# Access Compliance Report

## Public Rights-of-Way

### (Curb Ramps)

Intersection ID: 7563	Main Street: WALDON_RD	Cross Street: SHARPES_CR	Location: SW
ADA ID: 5690A0338B8C	Ramp Type: Perp	Initial Pass/Fail: Fail	Overall Compliance: No
Severity Score: 8.75			
Codes/Mitigation Info/Possible Solution		Field Measurements/Component Compliance

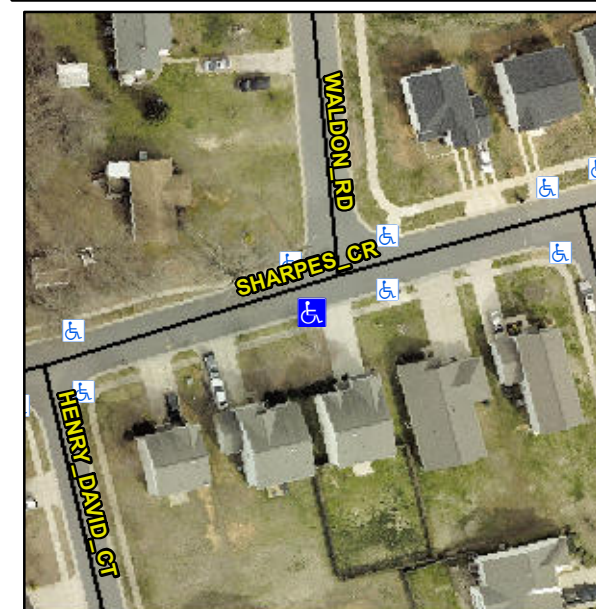
**Not Found, R304.5.1**

Compliance	Description	Data	Compliance	Description	Data
N/A	Ramp Length (in)	49.0	Yes	Ramp Slope (%)	5.5
No	Ramp Width (in)	47.5	Yes	Ramp XSlope (%)	1.5
N/A	Flare Type LT	N/A	N/A	Flare Type RT	N/A
N/A	Flare Slope LT (%)	N/A	N/A	Flare Slope RT (%)	N/A
N/A	Flare Traversable LT?	N/A	N/A	Flare Traversable RT?	N/A
N/A	Landing Length (in)	N/A	N/A	DWS Provided?	N/A
N/A	Landing Width (in)	N/A	N/A	DWS Contrast?	N/A
N/A	Landing Slope (%)	N/A	N/A	DWS Length (in)	N/A
N/A	Landing X Slope (%)	N/A	N/A	DWS Full Width?	N/A
N/A	Landing Curb? (Y/N)	N/A	N/A	DWS Offset (in)	N/A
N/A	Shared Landing?	N/A			
N/A	Gutter Ponding?	N/A	N/A	Gutter Slope (%)	N/A
N/A	Gutter Lip Ht (in)	N/A	N/A	Gutter X Slope (%)	N/A
N/A	Painted X Walk1?	No	N/A	Painted X Walk2?	N/A
	X Walk 1 Direction	To N		X Walk 2 Direction	N/A
N/A	X Walk 1 Width (in)	N/A	N/A	X Walk 2 Width (in)	N/A
	X Walk 1 Slope (%)	6.5		X Walk 2 Slope (%)	N/A
	X Walk 1 X Slope (%)	2.9		X Walk 2 X Slope (%)	N/A

**Remove & Replace Entire Ramp.**
